## **BID ADDENDUM NO. #2**

01/08/2026  
Town of Montour  
Havana Glen Park Improvements EPF237411  
1544-010

The following Addendum items shall be considered a part of the contract documents prepared by HUNT ENGINEERS, ARCHITECTS, LAND SURVEYORS & LANDSCAPE ARCHITECT, DPC.  
Bid Document date of 10/14/2025, Issued for Bid 12/01/2025.

**AD2-S1**

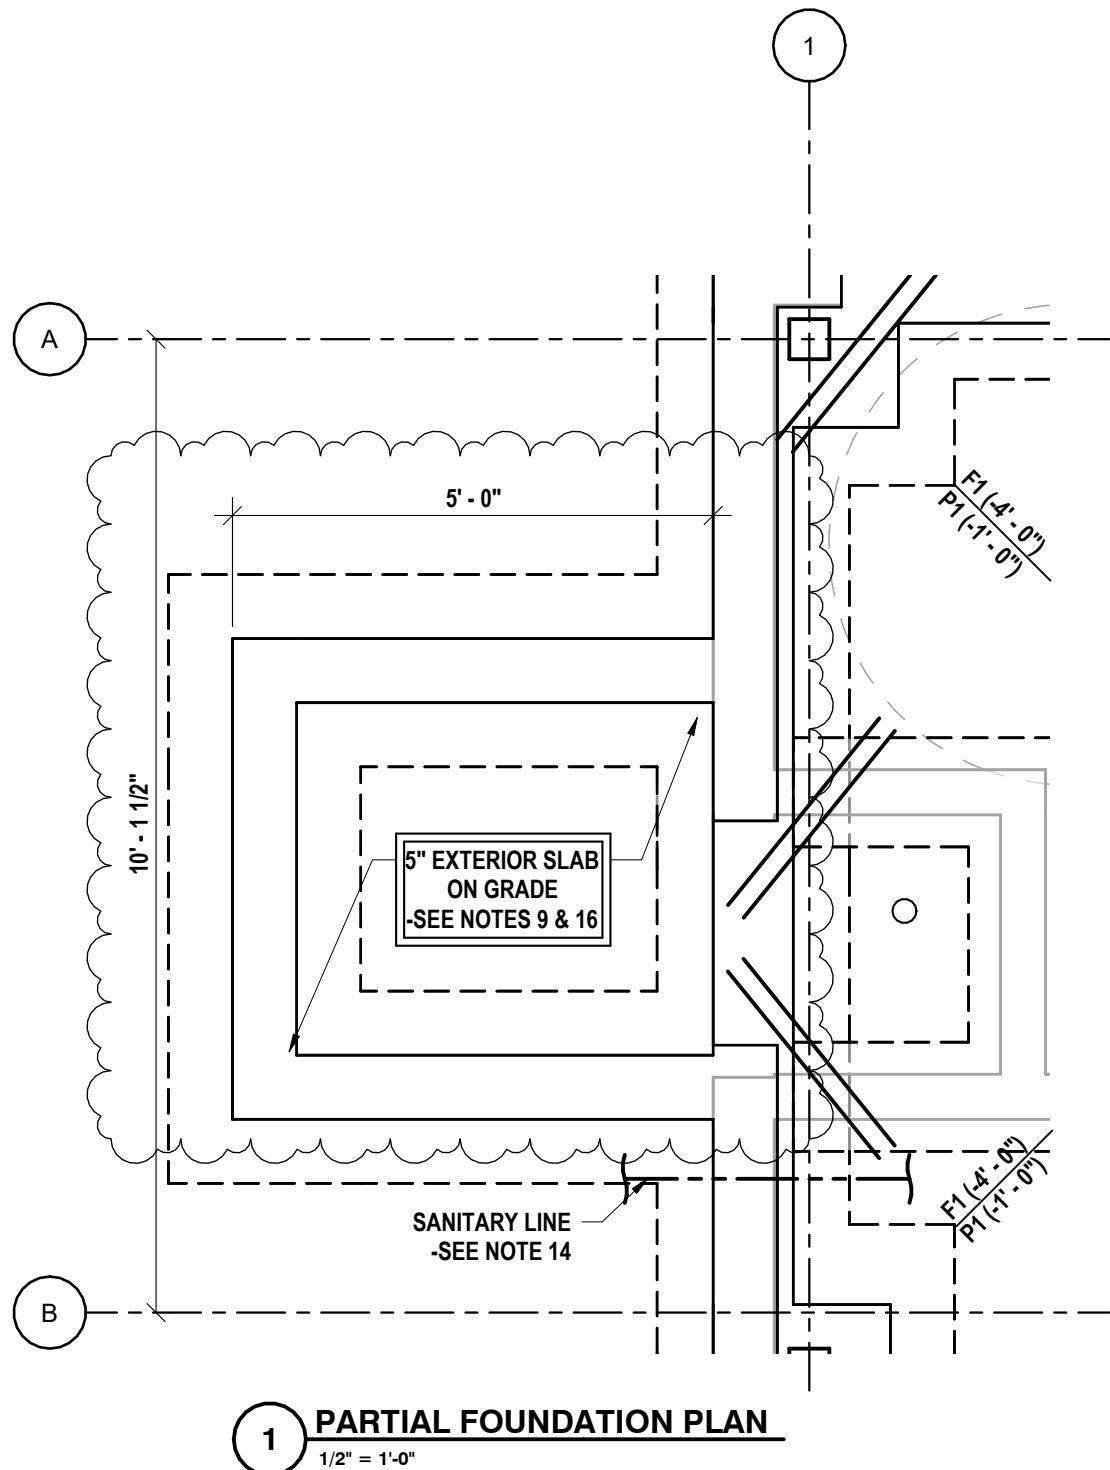
**ITEM AD2-11 Refer to S0.1 – STRUCTURAL GENERAL NOTES**

**ADD** Wood notes per AD2-S1 issued with this addendum.

-ADD WOOD NOTES TO SHEET S0.1

**AD2-S2**

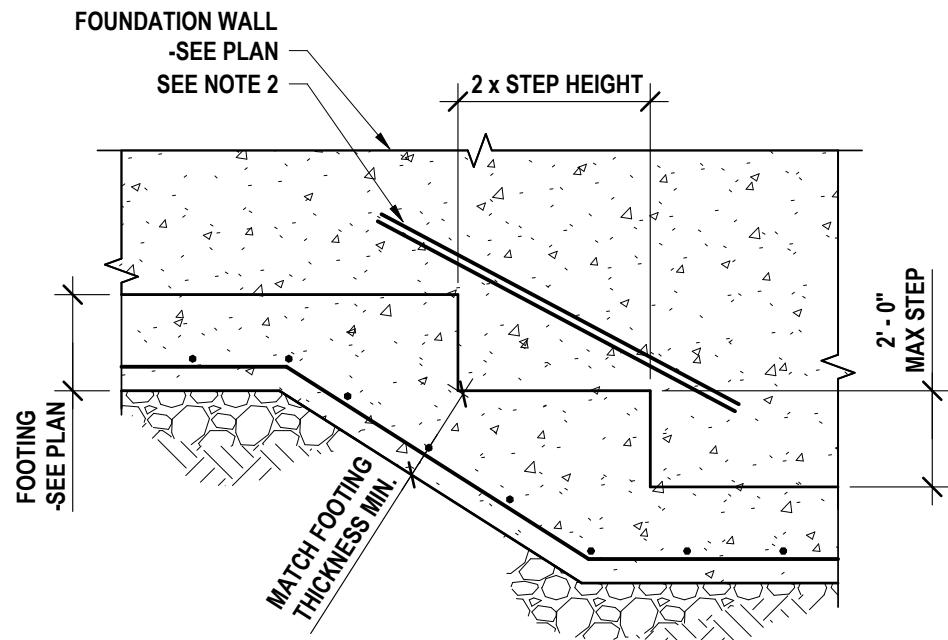
**ITEM AD2-12 Refer to S1.1 – FOUNDATION AND ROOF FRAMING PLANS**

**AMEND** Foundation plan 1/S1.1 per AD2-S1 as issued with this addendum.

**1 TYPICAL STEPPED FOOTING**  
1/2" = 1'-0"

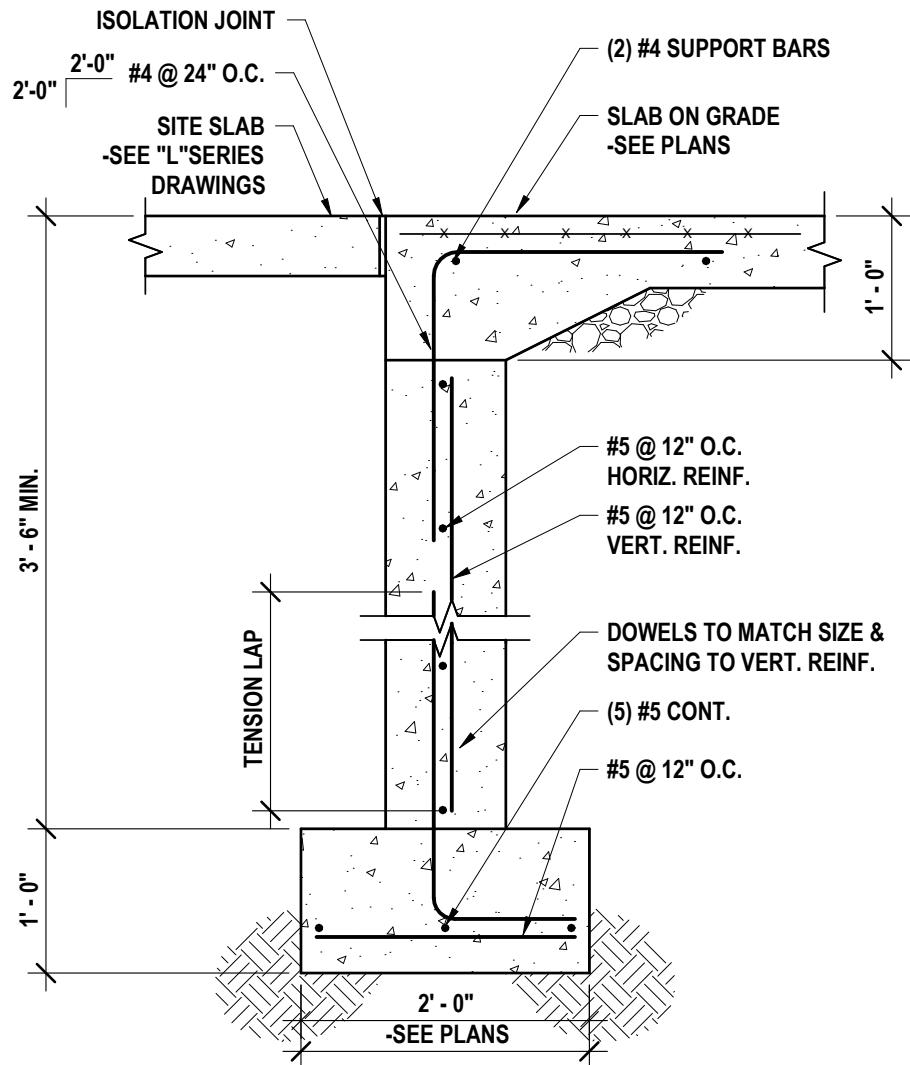
**ITEM AD2-17 Refer to S3.1 – FOUNDATION DETAILS**

**DELETE** Detail 1/S3.1 in its entirety.

**ADD** Detail 1/S3.1 per AD2-S3 as issued with this addendum.

-REPLACE DETAIL 1 ON SHEET S3.1

1. STEPS IN FOOTING ARE LIMITED TO GROUPS OF THREE WITH 8'-0" OF HORIZONTAL DISTANCE BETWEEN EACH GROUP (MIN).
2. ADD (2) #5 BARS AT EACH FACE OF WALL. RUN BARS PAST STEP BY 1'-0" MIN

8 **SLAB EDGE AT DOOR**  
3/4" = 1'-0"

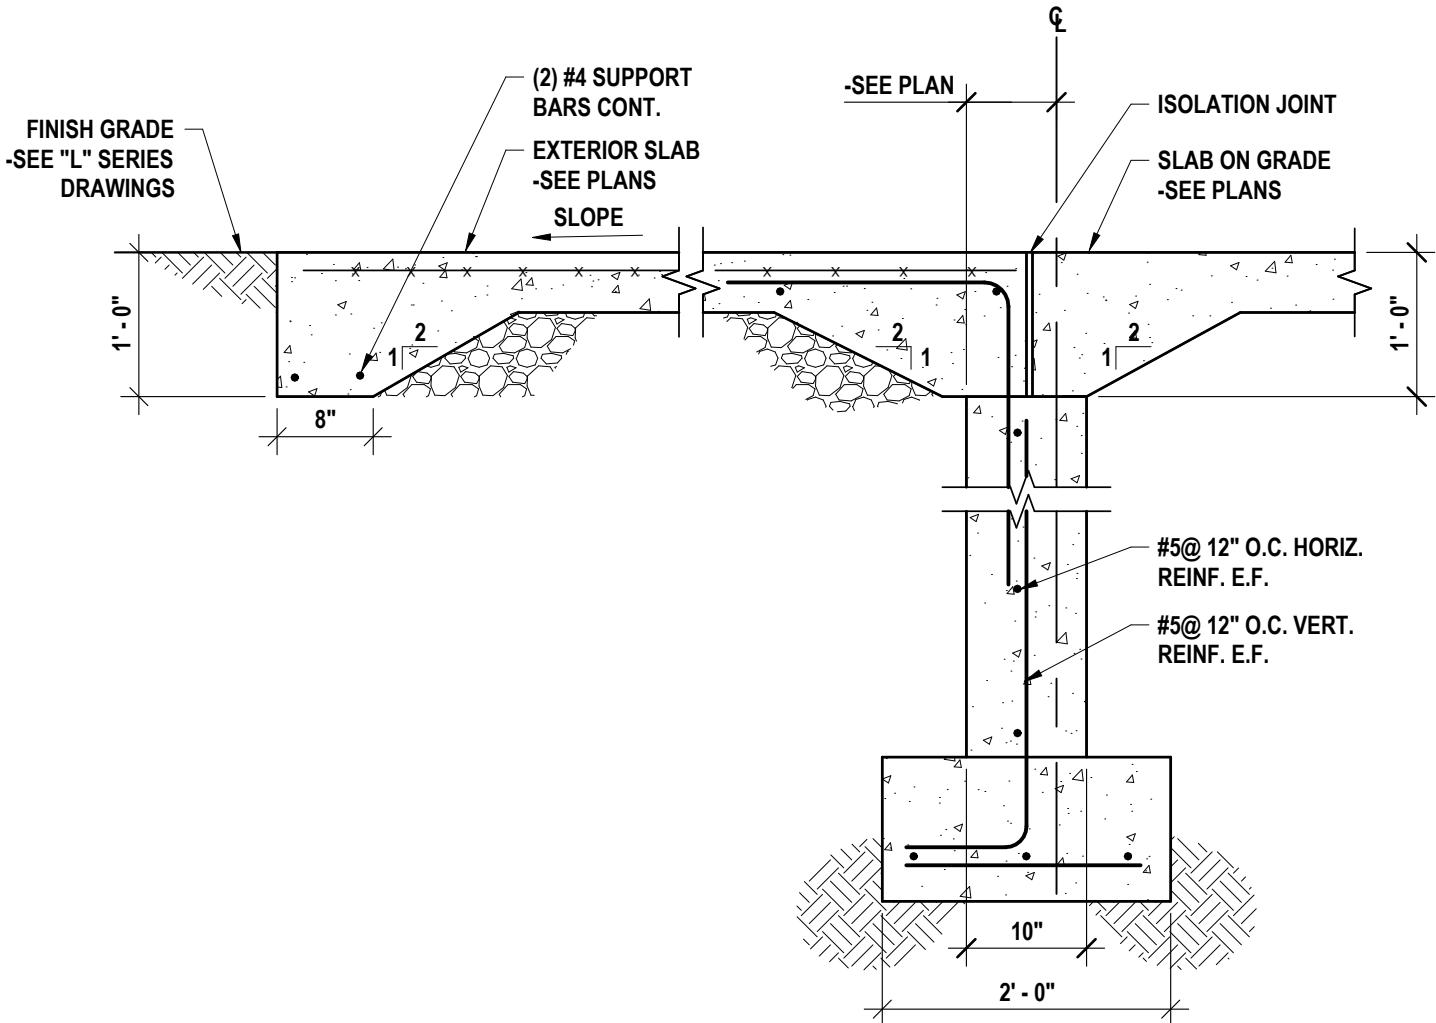
**ITEM AD2-18 Refer to S3.1 – FOUNDATION DETAILS**

**AMEND** Detail 8/S3.1 per AD2-S4 as issued with this addendum.

-AMEND DETAIL 8 ON SHEET S3.1

## 10 TYPICAL EXTERIOR SLAB

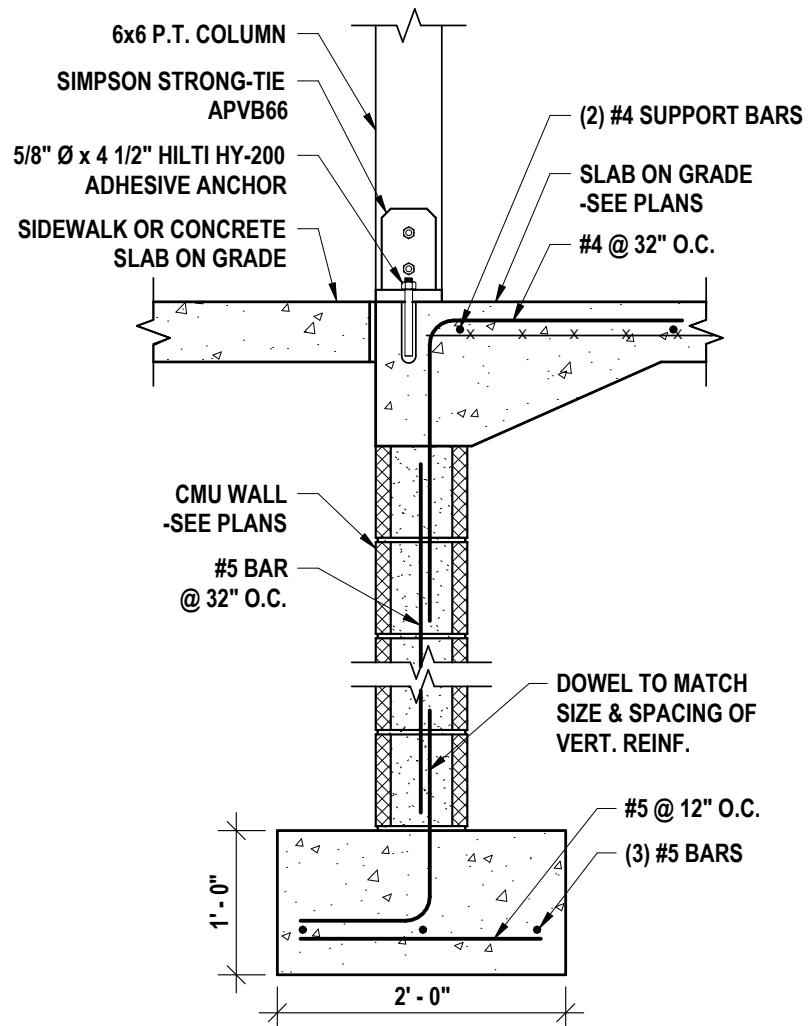
**ITEM AD2-20 Refer to S3.1 – FOUNDATION DETAILS**

**ADD** Detail 10 per AD2-S5 as issued with this addendum.

-ADD DETAIL 10 TO SHEET S3.1

**COLUMN BASE DETAIL - ALTERNATE #1**

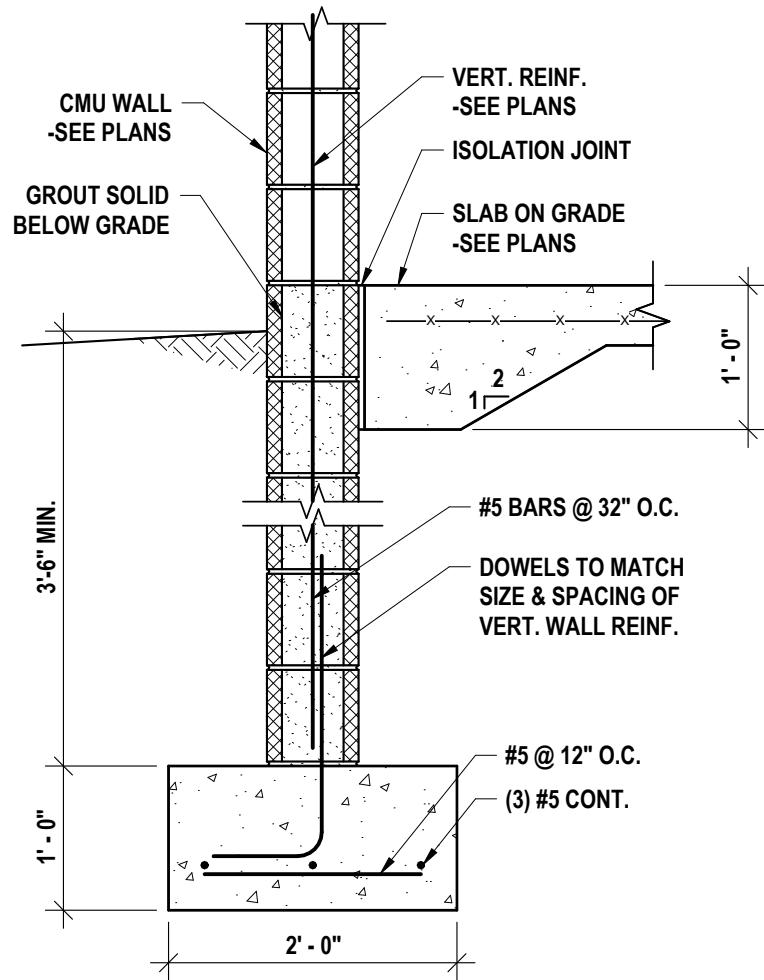
**ITEM AD2-21 Refer to S3.1 – FOUNDATION DETAILS**

**ADD** Detail 11 per AD2-S6 as issued with this addendum.

-ADD DETAIL 11 TO SHEET S3.1

**CMU FOUNDATION DETAIL - ALTERNATE #1**

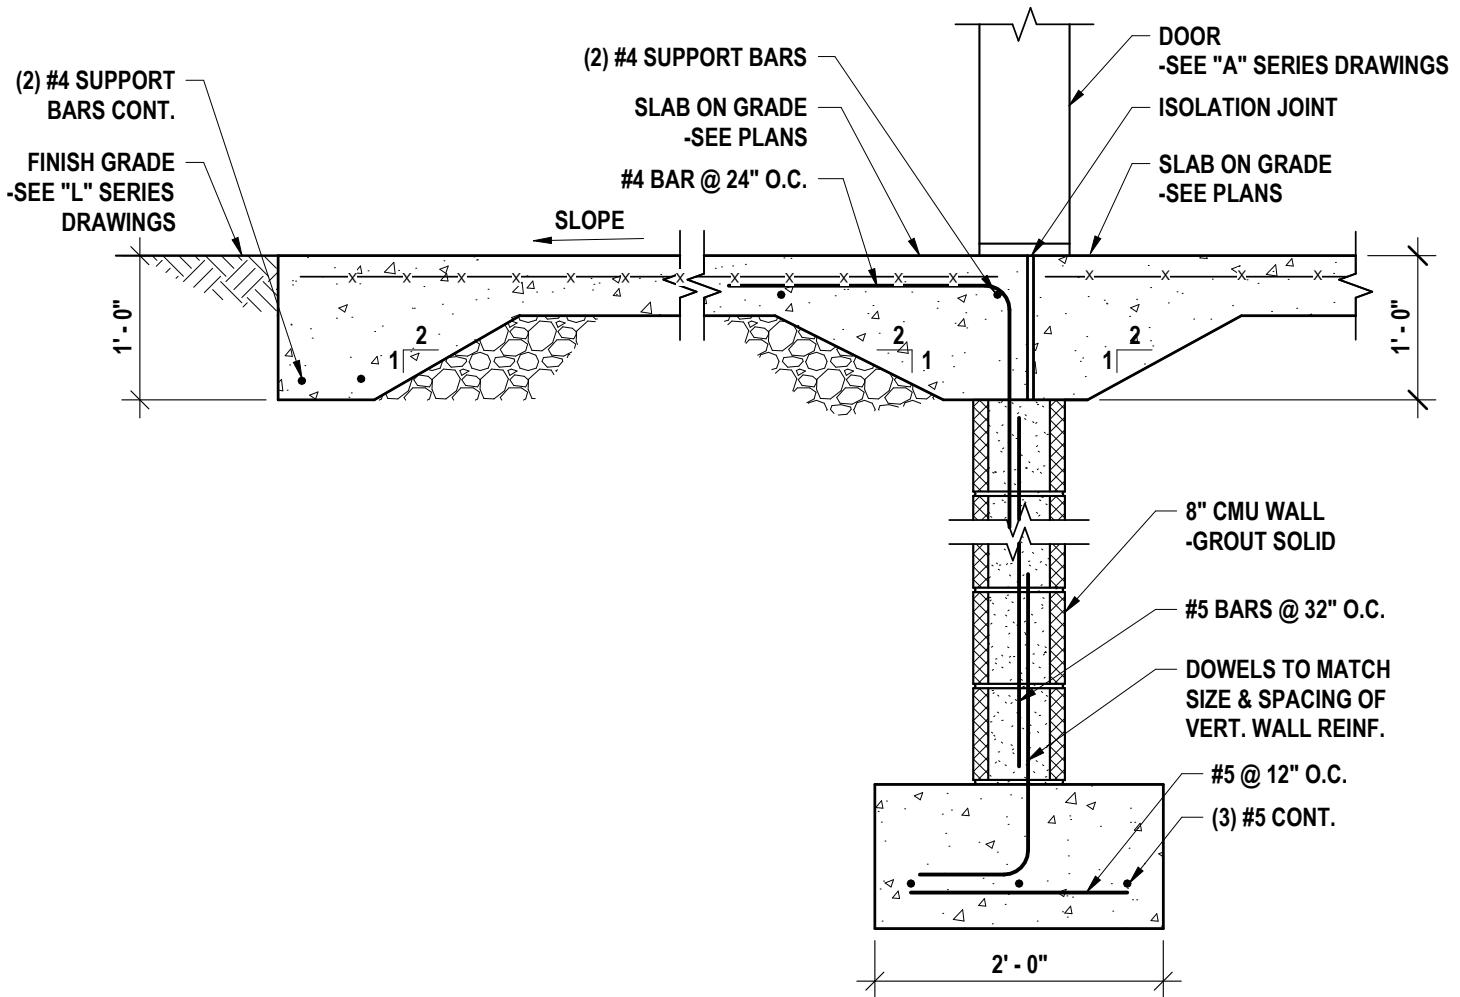
**ITEM AD2-22 Refer to S3.1 – FOUNDATION DETAILS**

**ADD** Detail 12 per AD2-S7 as issued with this addendum.

-ADD DETAIL 12 TO SHEET S3.1

**AD2-E1**  
PROJECT NO. 1544-010

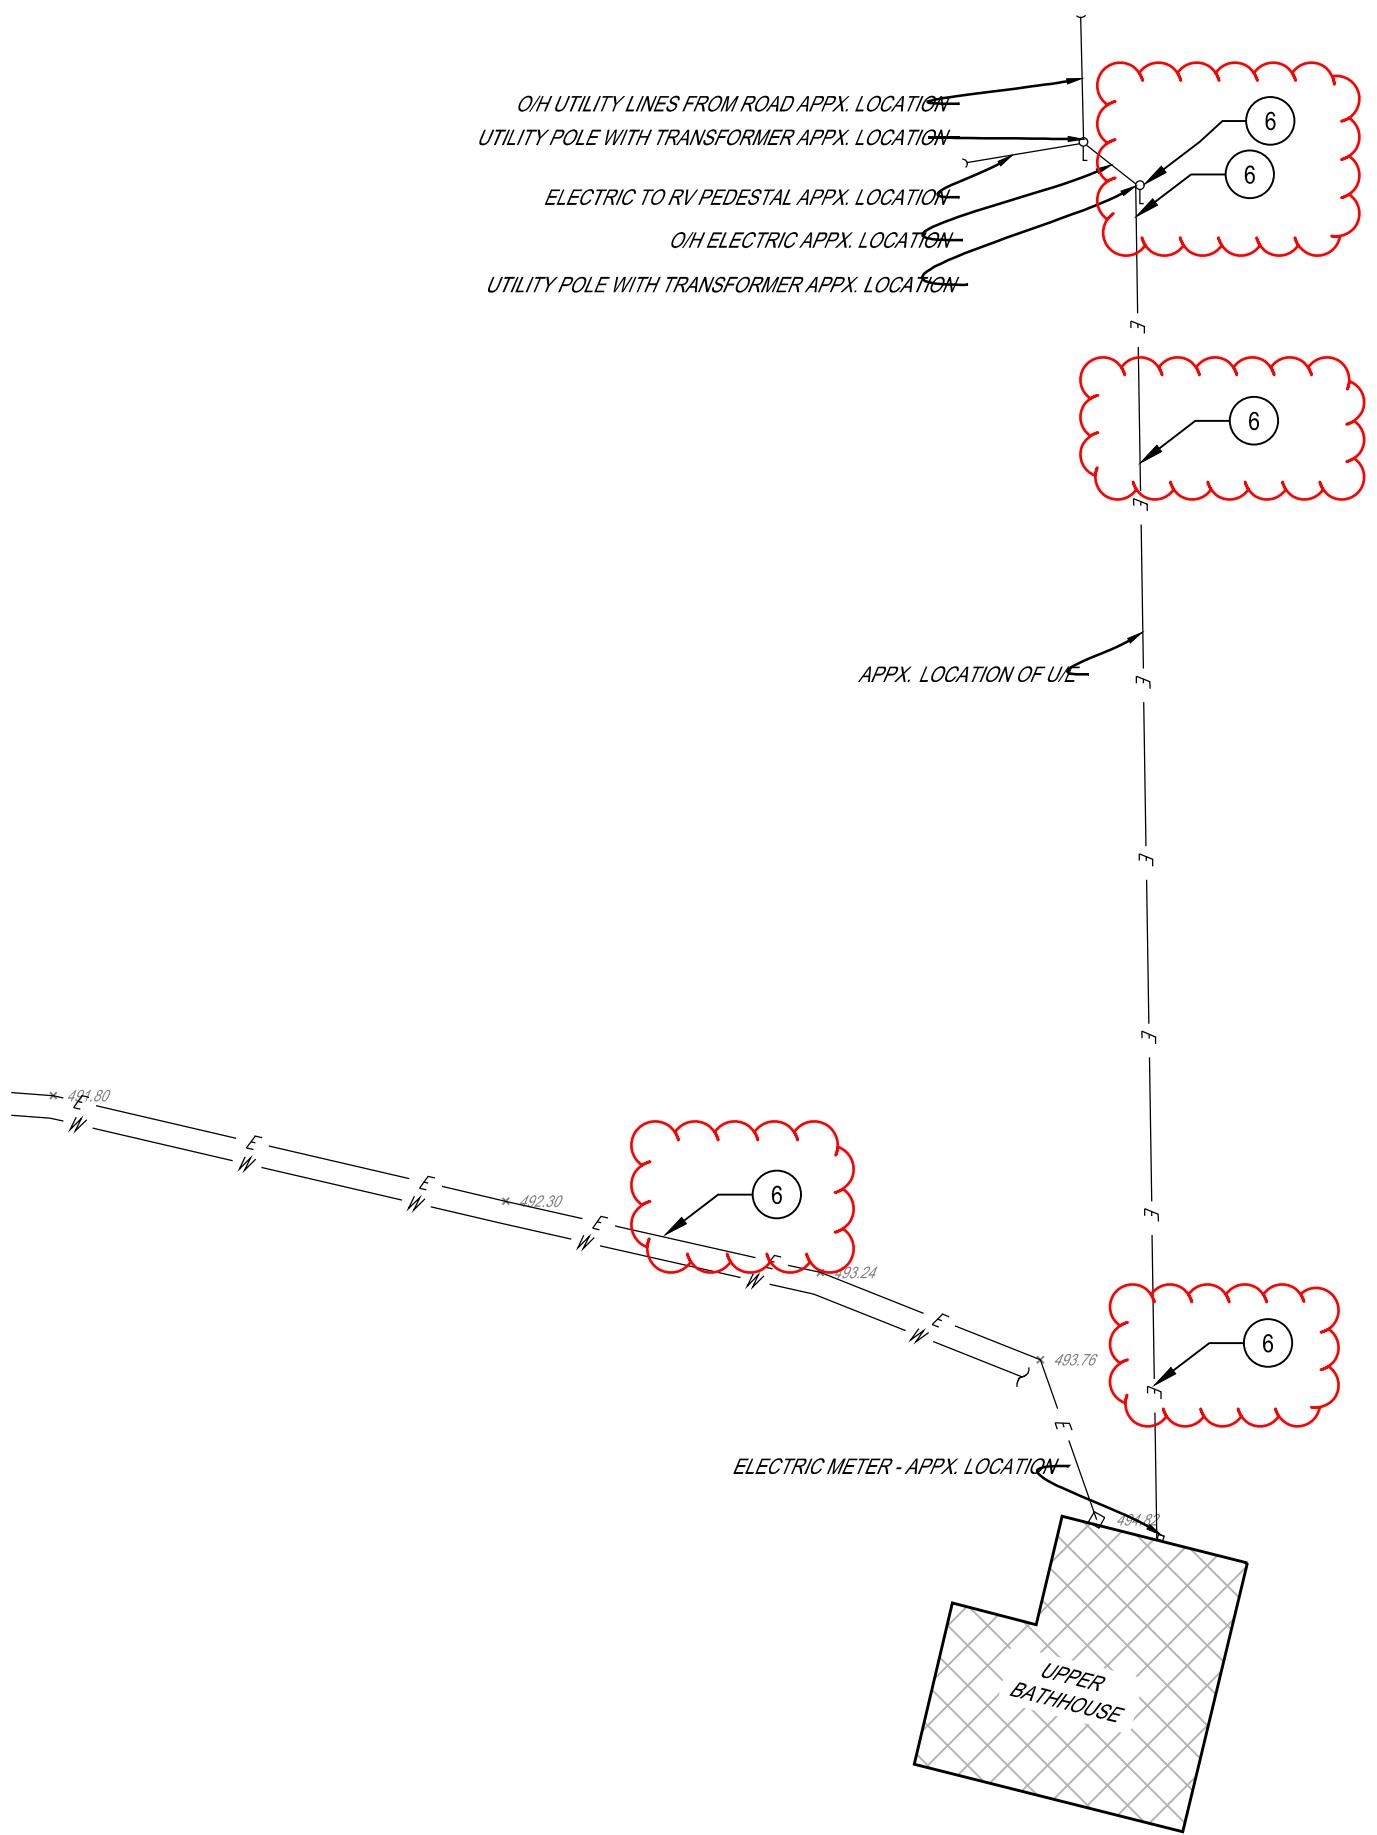
**ITEM AD2-9 Refer to L1.1 – SITE DEMOLITION PLAN**

**AMEND** Detail 2, with revisions made in AD2-E1 – ELECTRICAL DEMOLITION REVISIONS – UPPER BH as issued by this addendum.
